# Demolition of an existing house & the erection of a replacement house

35 Carseview Gardens

**Report by Head of Planning  
& Economic Development**

Figure 1 – Proposed Site Plan

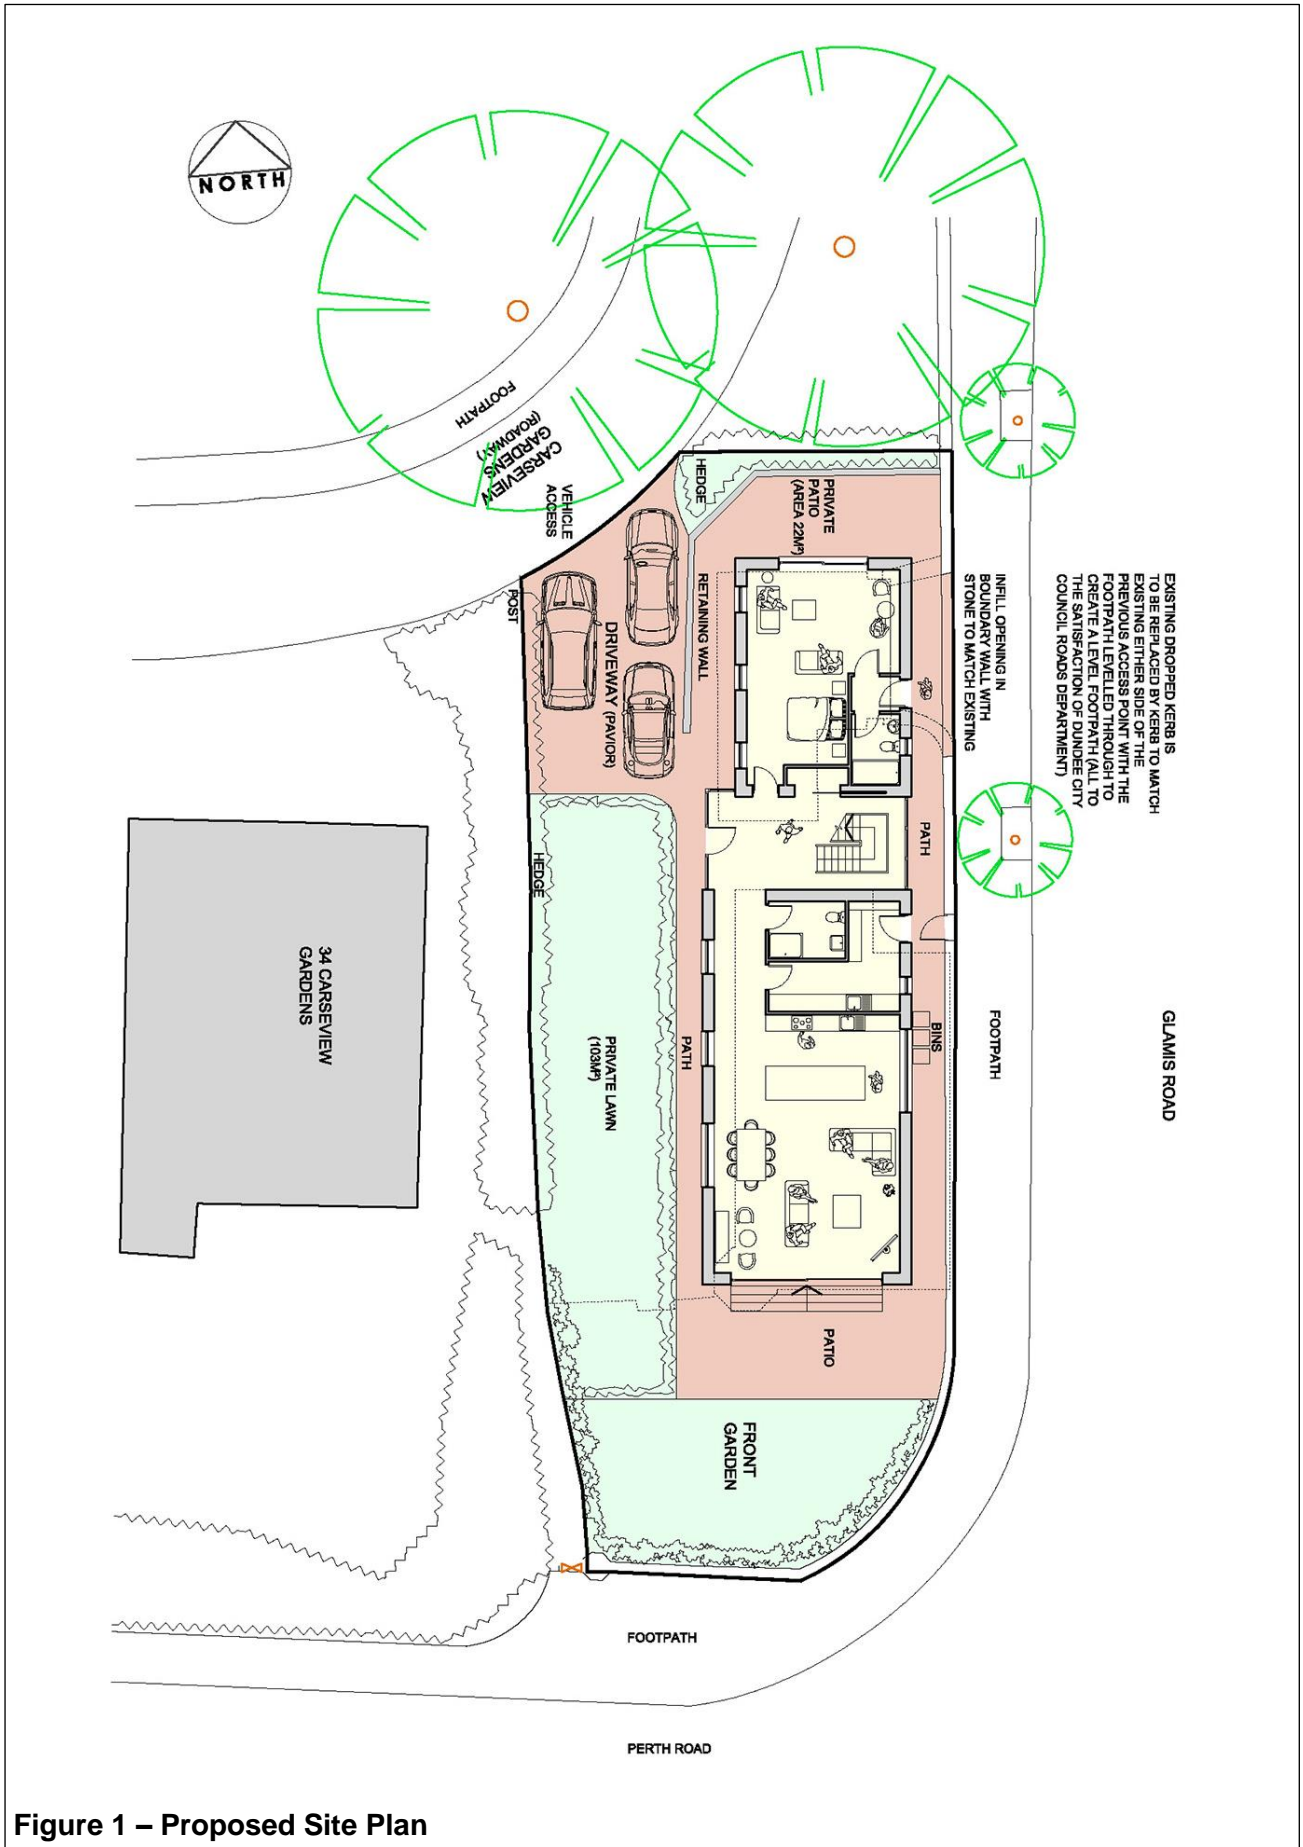
- 7.19 **Response** – the Design Statement refers to cycle storage being provided however it is not shown on the proposed plans. A condition is therefore recommended, should planning permission be granted, to ensure further detail on the design and location of the cycle storage is submitted for written approval by the Council. This standard is met, subject to condition.

- 7.24 **General Requirements** - provision for waste and recycling should be provided in accordance with the Council's waste management strategy.
- 7.25 **Response** – waste storage is shown on the Site Plan. This standard is met.

Figure 2 – Proposed North and East Elevations

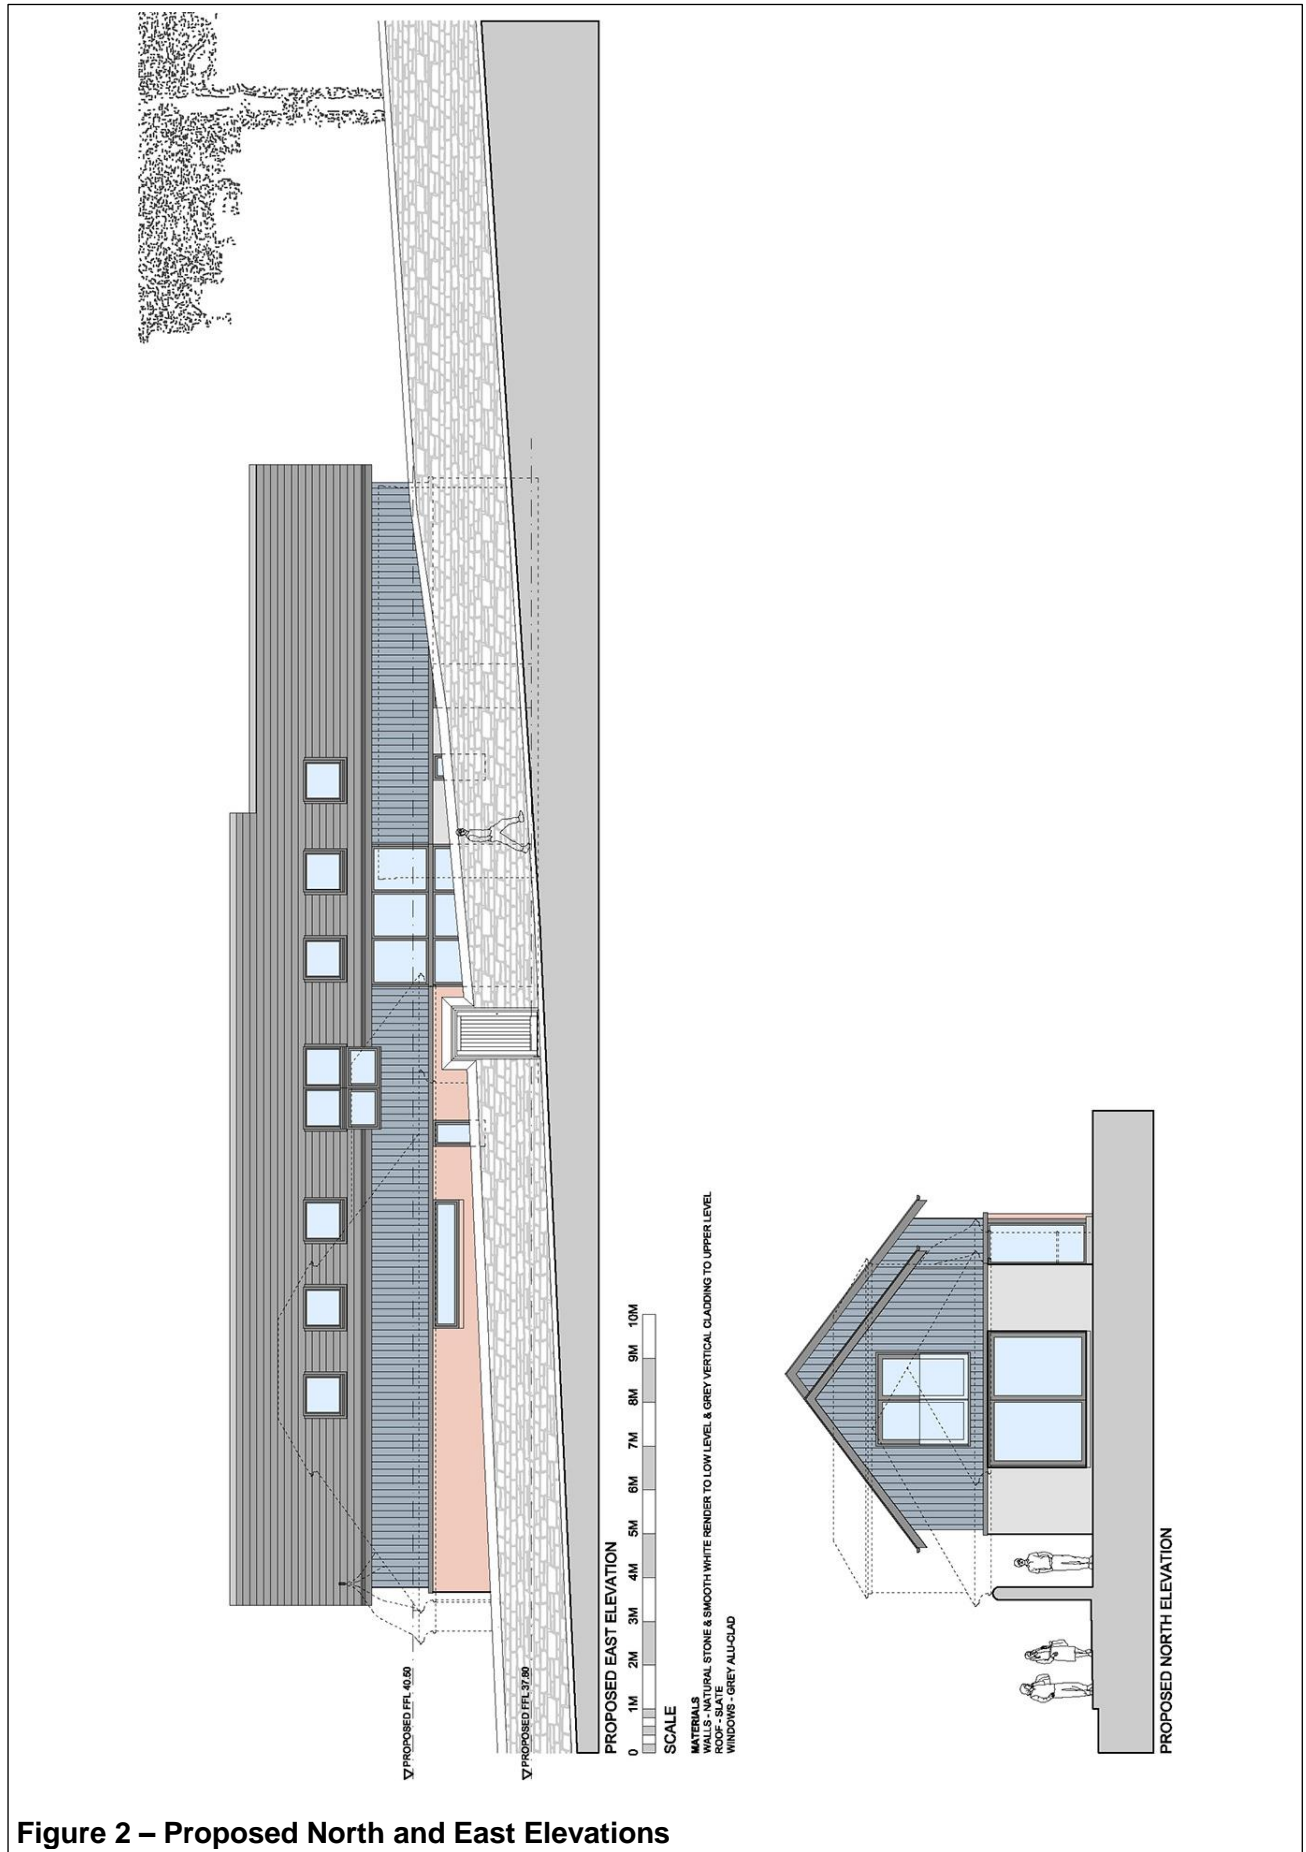
- 7.8 The proposed new house is a contemporary bespoke design which is sympathetic to the site topography and the elongated nature of this prominent corner site. The design has evolved during the application process and the applicant has taken account of the comments and representations received. The introduction of a step down and break in the roofline helps to soften the linear design and massing of the new build. This is complemented by a more sensitive blend of contemporary and traditional finishes and the location and design of the window openings has been revised to respect neighbouring residential amenity.
